Re: **Ocean Drive (CR619) Bridge over Corsons Inlet
Railing Improvements
Upper Township, Cape May County, NJ
ADDENDUM NO. 1**

ADDENDUM NO. 1

OCEAN DRIVE (CR66) OVER CORSON'S INLET RAILING IMPROVEMENTS STR. NO. 3100-002 (CORSONS INLET BRIDGE)

OPTIONAL WORK - CONCRETE DECK REPAIRS

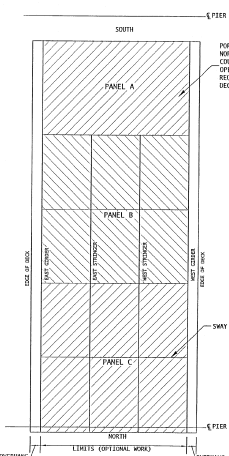
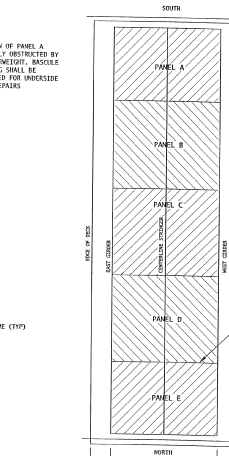
Sheet 28: *Add attached Sheet 28A of 28 (Option Work – Concrete Deck Repairs) immediately after Sheet 28.*

REPAIR OF CONCRETE DECK, TYPE OB SHALL BE COMPLETED PER DETAIL "PARIAL DEPTH TYPE B REPAIR".
 REPAIR OF CONCRETE UNDERDECK, TYPE OU SHALL BE COMPLETED PER DETAIL "FULL DEPTH TYPE C REPAIR".
 REPAIR OF CONCRETE UNDERDECK, TYPE OU SHALL BE COMPLETED PER DETAIL "UNDERDECK REPAIR", REGARDLESS OF PRIORITY.
